CERTIFICATE OF APPROPRIATENESS

ITEM A02
HPO File #: HP2026_0286

509 Euclid St.
Woodland Heights

Proposal: Alteration – Addition

ATTACHMENT A

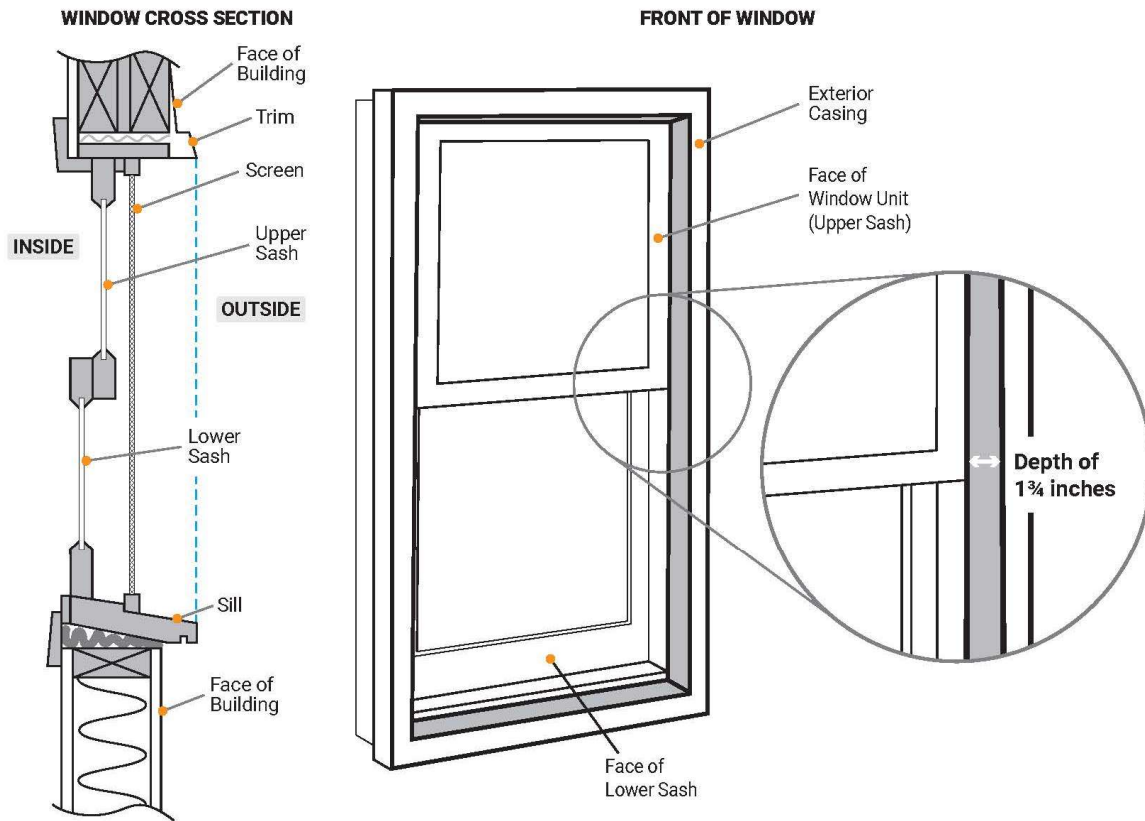
- All new windows need to be inset and recessed. See Attachment A for details.

Minimum 1 $\frac{3}{4}$ inch Inset

- Depth from Exterior Casing to the Face of the Window Unit (Upper Sash)
- Windows must be 1-over-1 (equally horizontally divided)
- 1 $\frac{3}{4}$ inch minimum inset for Fixed Window
